**Project #21-063
Logan Building
Located at 1210 W 600 N**

<i>Project Name:</i>	Logan Building
<i>Proponent / Owner:</i>	Brandon Roberts / ArrowHead Labs
<i>Project Address:</i>	1210 West 600 North
<i>Request:</i>	Design Review
<i>Current Zoning:</i>	Commercial Services (CS)
<i>Type of Action:</i>	Quasi-Judicial
<i>Hearing Date</i>	October 14, 2021
<i>Submitted By:</i>	Tanya Rice, Planner II

Staff recommends that the Planning Commission **conditionally approve** a Design Review for Project #21-063, Logan Building's commercial building located at approximately 1210 West 600 North, TIN #05-061-0005.

Figure 2 shows East elevation of flex commercial building.

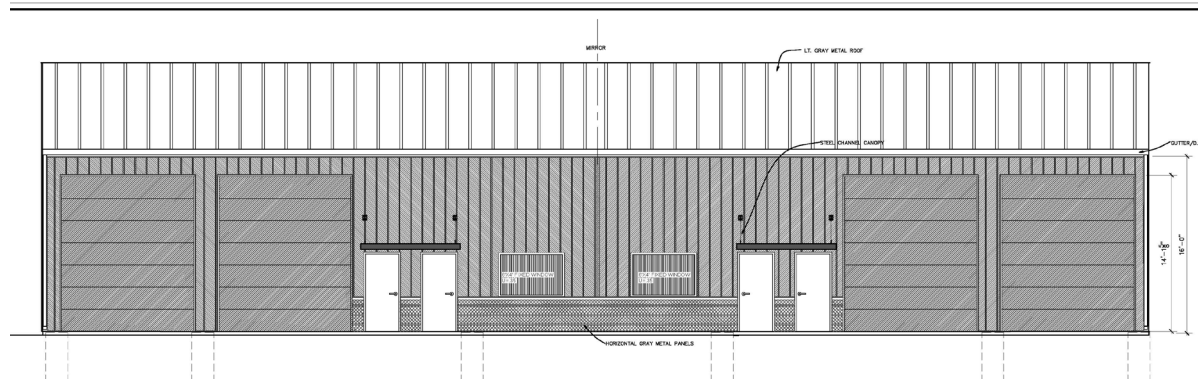
The LDC standards for the CS zone require that building design be compatible with surrounding uses. Even though this site is on the edge of town, growth in the area is inevitable so it is appropriate to apply all standards to the project. The proposed building is metal clad with a pitched roof. The CS standards require minimal building form features to break-up building mass and scale. The LDC states that blank walls greater than 40' are not permitted along facades visible from a public street, and that two methods must be used to create interest and reduce scale. Methods mentioned in the code include staggering of vertical walls, recessing openings, providing upper-level roof overhangs, using deep score lines at construction joints, contrasting compatible building materials, and using horizontal bands of compatible colors. The proposed building design elements on the north (front) and east elevations meets the CS requirements due to the variation in building colors, textures, orientation, horizontal banding, window & door breaks, and canopy covers over the doorways. The west façade is blank and needs some architectural breaks every 40'. As conditioned, all elevations comply with the requirements of the LDC.

North Elevation (600 N Frontage): 11%
 East Elevation (600 N Exposed Side): 3%
 West Elevation (600 N Exposed Side): .5%

1. All standard conditions of approval will be recorded with the Design Review and are available in the Community Development Department.
2. Facades exposed to the street (north, east, west) on the commercial building shall contain 30% transparency and similar architectural details.
3. The west façade shall have architectural breaks every 40'.
4. A performance landscaping plan, prepared in accordance with §17.32 of the LDC, shall be submitted for approval to the Community Development Department prior to the issuance of the building permit. The plan shall include the following:

sheet number: A1.0 Site Plan	DATE: 8-1-21 PROJECT NO: DRAWN: WBS CHECKED: revisions:	1210 W 600 NORTH ST LOGAN UTAH INSULATED STORAGE BUILDING Vanilla Shell	Architectural Productions Ward Schwider 1716 N 32nd BOISE, ID 83703 tel: 859-2336 email: schwider1@juno.com
---	---	--	--

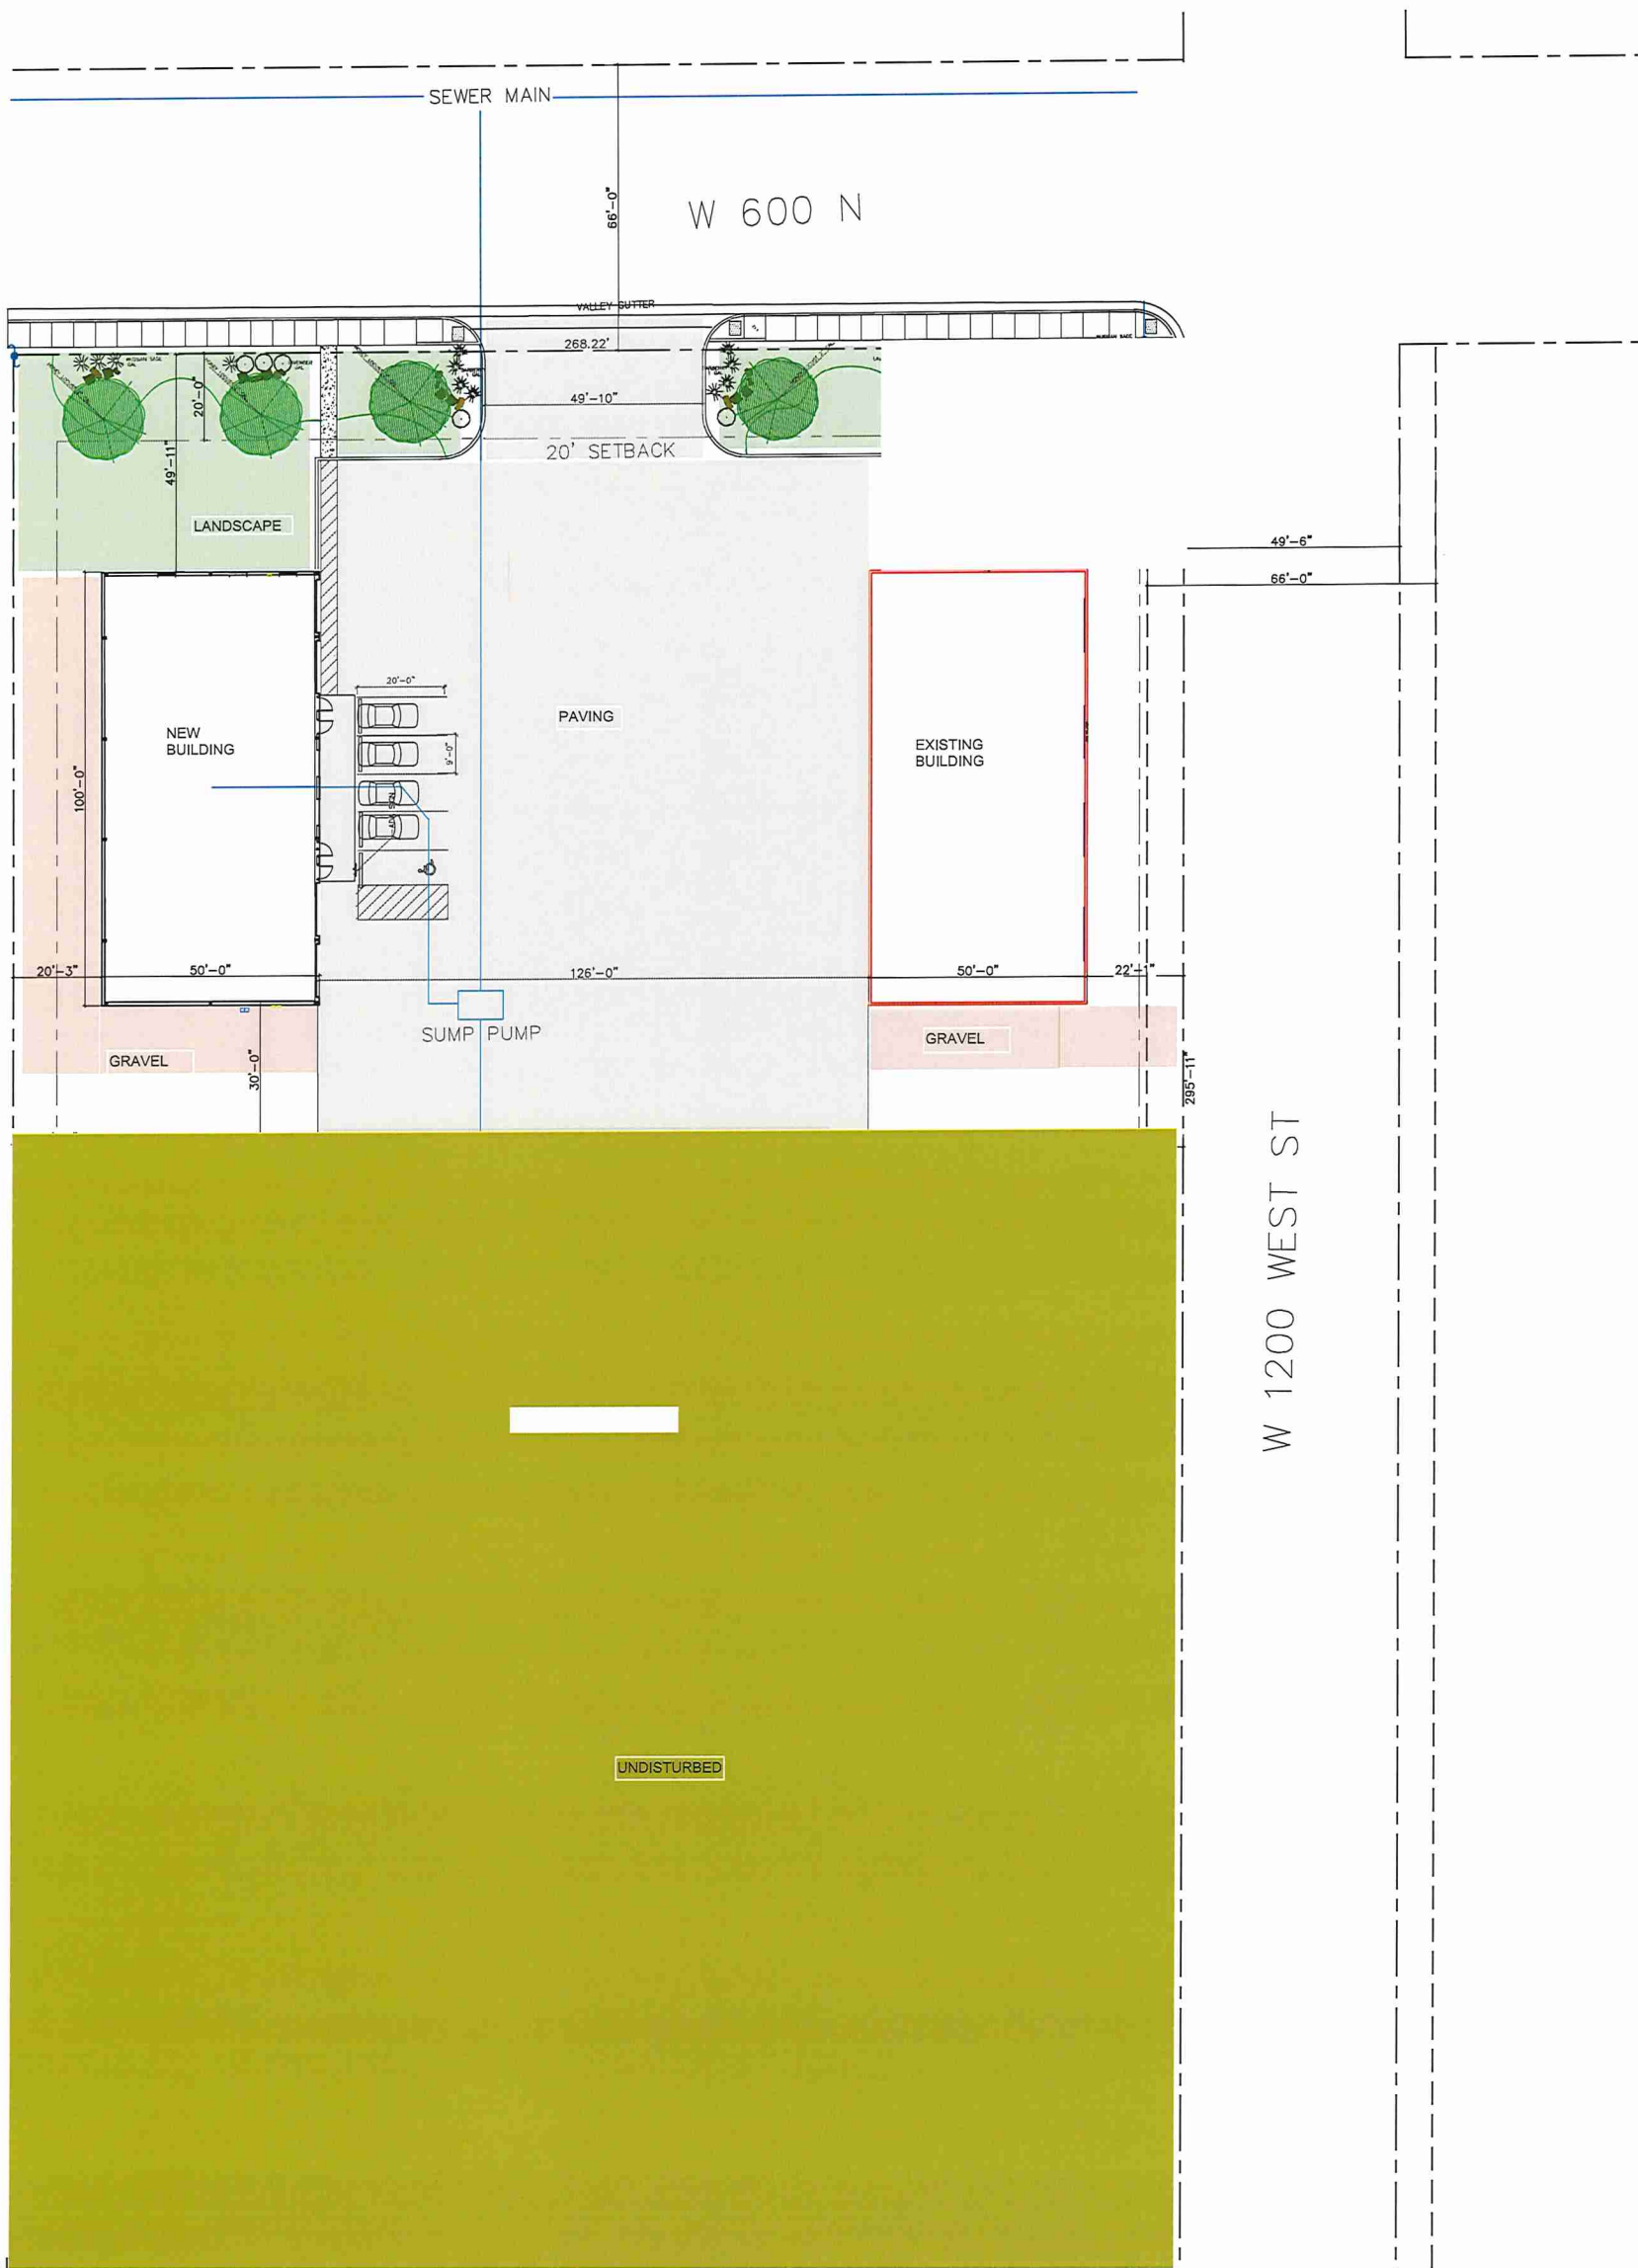
The proposed site plan includes the new 5,000 SF building fronting 600 North and associated site development. The proposed project is located on the northern 1.10-acre portion of the parcel while the remaining acreage to the south will remain undisturbed and available for future development. The proposal includes a sidewalk from the north side of the building connecting to a sidewalk along 600 N. Parking is proposed on the west of the building and consists of 5 stalls. Four roll-up doors are accessed on the west side of the building, two on each side of the parking area. The gravel areas adjacent to both buildings is intended for storm-water detention. The site plan includes a driveway accessible from 600 North that will serve both buildings. There is an undeveloped 1200 West right of way on the east side of the property that will also need to be improved to City standards.

Vehicle access to the proposed building will be from 600 North. The existing building has a current access off of the 1200 West ROW which will be required to be improved. Pedestrian connections will be installed from the parking area to 600 N. As proposed, the project complies with the requirements in the LDC.

- a. *Fire—contact 716-9515*
 - Additional fire hydrant required.
 - b. *Environmental- contact 716-9761*
 - Minimum 60 ft. straight on access required. Approach must be level, no down or uphill slopes.

- Dedicate necessary right of way along 1200 West to ensure that a 66' right of way is maintained.
- Construct half of a road along 1200 West as a 66' Gridded Street. Design pavement section to be that of a Collector type road per City design standards. Public Works has agreed to record a document with property owner allowing street improvements along 1200 West to be completed with the development of the remainder parcel.
